Coastal Access - Aldeburgh to Hopton-on-Sea

Representations on AHS 4 - Southwold to Pakefield and Natural England's comments

June 2023

The red line on the map shows route of the existing Suffolk Coast Path

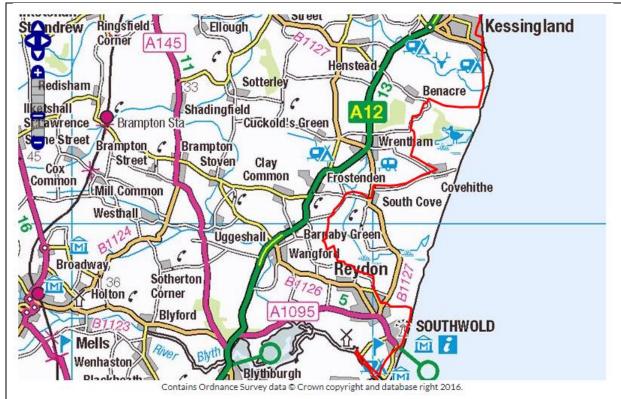
The representations suggest that people can follow public rights of way, without the need for any Optional Alternative Routes not on public rights of way, and that the existing Suffolk Coast Path could be used as an OAR.

AHS-4-OA025 should be removed. Walkers should be able to use AHS-4-OA026 as an alternative route. As a consequential effect, AHS-4-OA024 should also be removed. As a compromise, we are willing to offer the "blue" route to provide a link to AHS-4-OA026 for walkers to use as an optional alternative route.

The proposed route for the KCIIIECP follows a route similar to the existing Suffolk Coast Path but departs from this in places in order to be closer to the sea and maintain sea views. In particular, the Suffolk Coast Path goes up to 2 miles inland between Easton Bavents and Benacre, and therefore this route doesn't provide a suitable, coastal OAR in this location (see map below).
